# Replacement of power transistors SRFH1008 and MRF455

## Introduction

This service bulletin affects the users of transceivers with power amplifier (PA) output transistors SRFH1008 or MRF455. There are two transistors (matching pair) on each PA PCB. The following transceivers are affected:

Figure 1: Power amplifier PCB for the 93xx series/9780 and LP transceivers

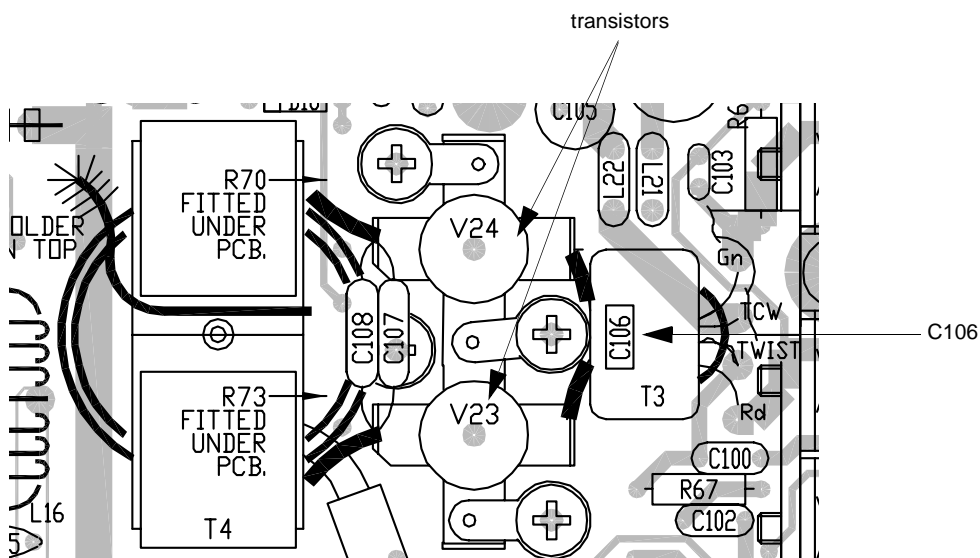
- Remove the two faulty transistors from the PA PCB (see Figure 1).

- Replace C106 with a capacitor that has a value of 470 pf.

Later model 93xx series/9780 PAs (Codan part number 08-04963-xxx) may already have the 470 pf capacitor in place. If you are unsure of the value of C106, it is recommended you replace it with a 470 pf capacitor as a precaution.

- Replace the transistors with MS1253-CDN.
- Continue from [page 3, Adjusting the driver bias for power amplifiers in 93xx series/9780 and LP transceivers.](#)

Figure 2: Power amplifier PCB for the 85xx series/9313/9480 transceivers

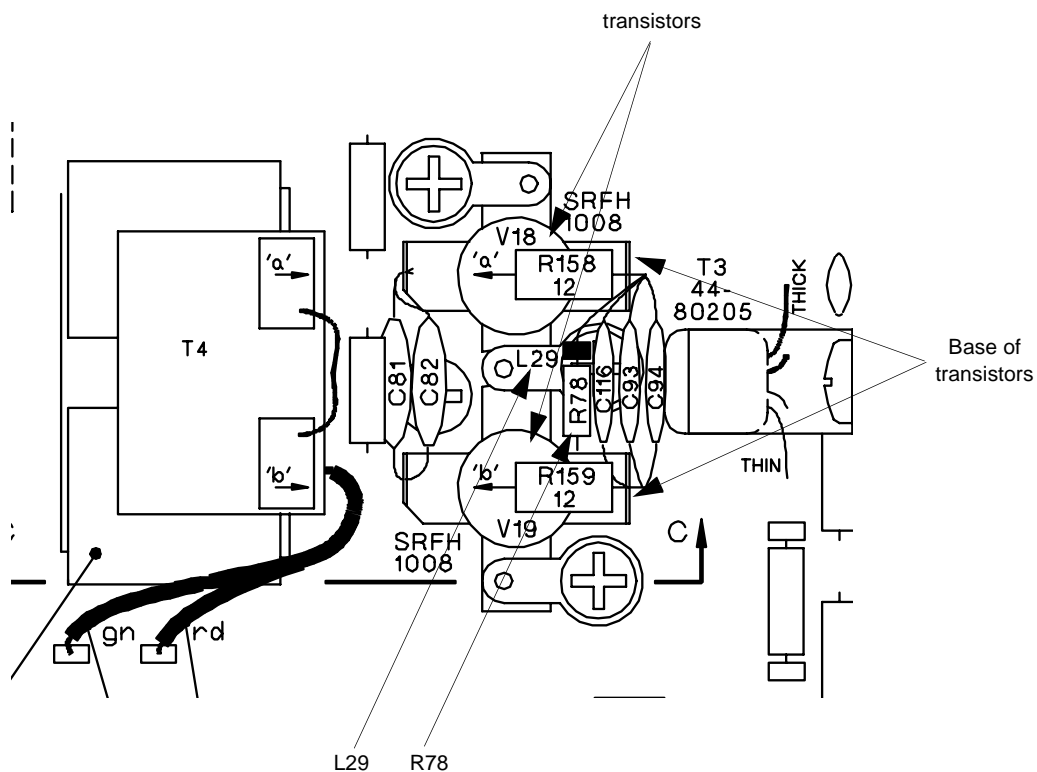
- Check if there is a resistor/choke (R78/L29) across the base of both transistors on the PA PCB (Codan part number 08-03743-xxx) (see Figure 2).

If R78/L29 is not present, it must be fitted.

Without the resistor/choke in place, spurious oscillations at approximately 4 MHz occur. The resistor/choke network consists of a:

- ↪ • 12  $\Omega$  ¼ W 5% resistor
- ferrite bead placed on one leg of the resistor with a small amount of silastic to stop any movement

- Replace the transistors with MS1253-CDN (see Figure 2).
- Continue from [page 5, Adjusting the output bias in all transceivers](#).

Figure 3: Replacing the fuse

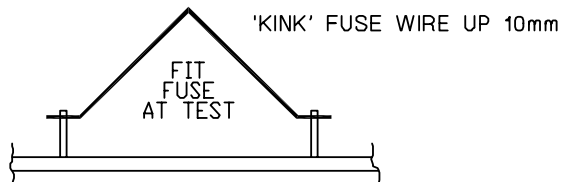
- If the **PA O/P** fuse is broken, do the following:
  - Replace the **PA O/P** fuse with two strands ( $2 \times 0.2$  mm TCW) taken from a piece of  $7 \times 0.2$  mm cable.
  - Solder the wire ends to the stakes as shown in [Figure 3](#).
  - Kink the wire up 10 mm to form an inverted V as shown in [Figure 3](#).
